June 5, 2013

**Re: Storm Water Inspection at McDonalds Restaurant-Obetz / Franklin County  
Permit Number: 4GC04043\*AG**

**Figure 2: Silt fence on southeast corner requires maintenance**

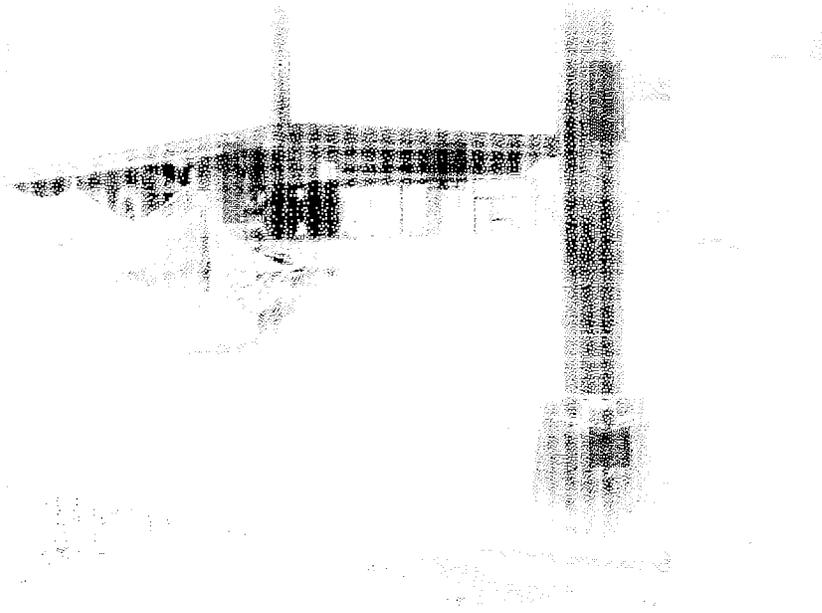
- The silt fence on the southeast portion of the site has failed and will require maintenance at this time (See Figure 1 & 2).
- The spill noted in Figure 3 should be properly collected and disposed of in order to ensure compliance with the Ohio EPA General Storm Water Permit.
- Please be aware that the General Permit indicates that all sediment controls will be inspected and maintained every seven days or within 24 hours of a precipitation event equal to or greater than 0.5 inches. A log of inspection must be maintained on site for the agency to review.
